**TOWN OF FAIRFAX
STAFF REPORT
Department of Planning and Building Services**

TO: Fairfax Planning Commission
DATE: July 20, 2017
FROM: Linda Neal, Principal Planner
LOCATION: 125 Live Oak Avenue; Assessor's Parcel No. 001-236-03
ZONING: Residential RD 5.5-7 Zone
PROJECT: 50% remodel/expansion of single-family residence
ACTION: Move to Continue Action on Hill Area Residential Development permit, Parking Variance, Design Review and Encroachment Permit; Application # 17-13
APPLICANT: Dan Bettencourt
OWNER: DJB Property Solutions L.L.C
CEQA STATUS: Categorically exempt, § 15301(a)

125 LIVE OAK AVENUE

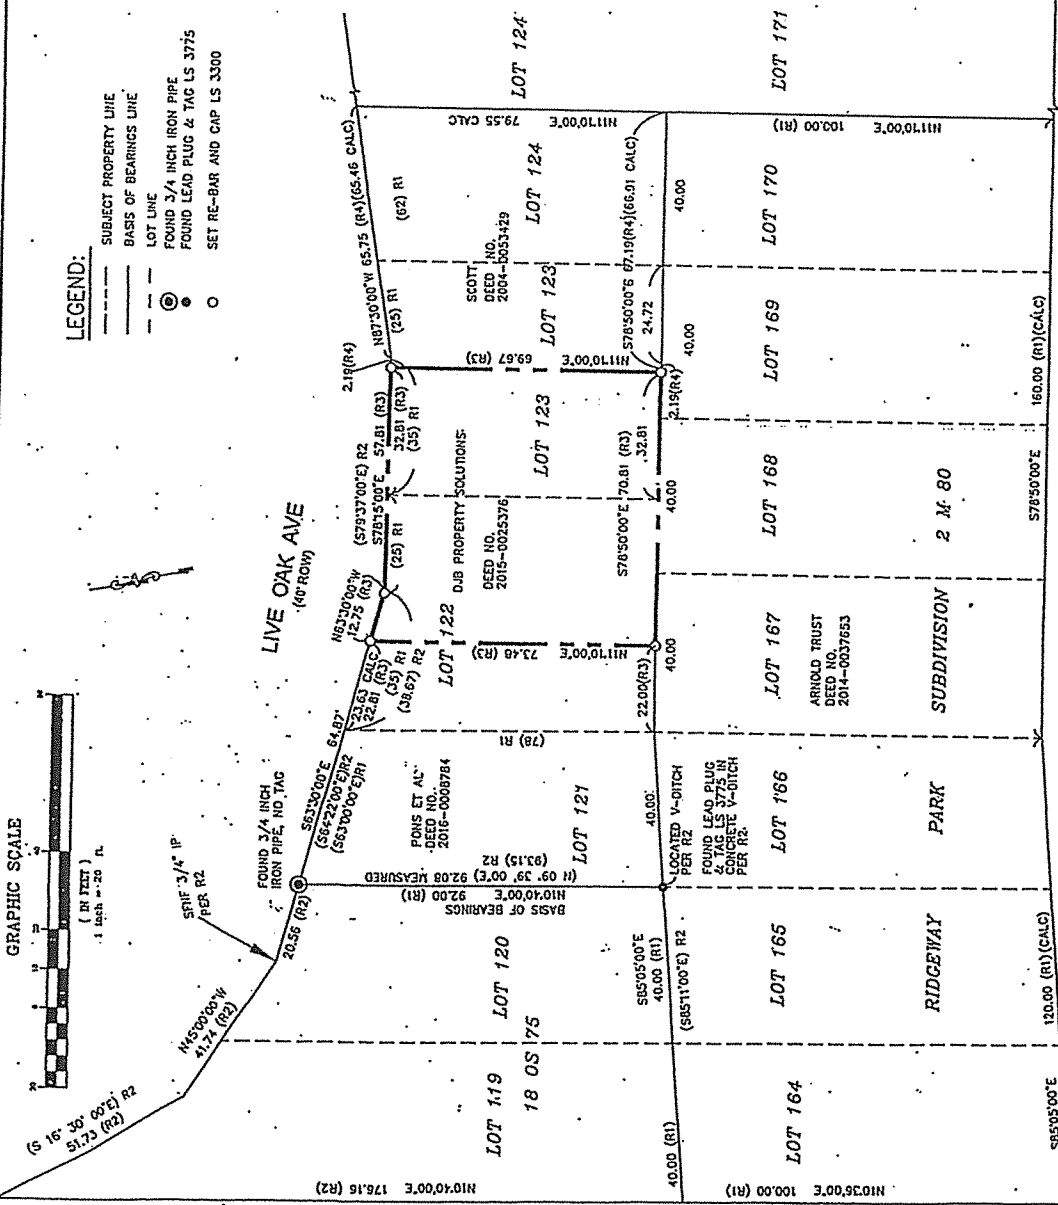
The area of the Fire Fighter Turn-around was required to be added to the topographic survey including the surveyed (record of survey) right of way lines, trees, fences, sign, existing utilities and paving. The provided record of survey does not show the street right of way lines on the northerly side of the Fire Fighter Turn-around so we have fairly weak information on where the right of way or property line is in this area. The sheet A0.1 and the topography show the right of way at about 40' wide which may be correct and the turn-around area is shown based on that. It looks okay. I will leave it to you to decide if we should go through another plan review to get the accurate property line location that was previously required for the turn around area.

6. The R/S is only concerned with property boundary determination based on monuments and documents of record. The R/S does not show the north street boundary mostly for lack of space, although this boundary plays no role in the R/S objective, the 40-ft right of way is clearly (and firmly) shown under the street name.
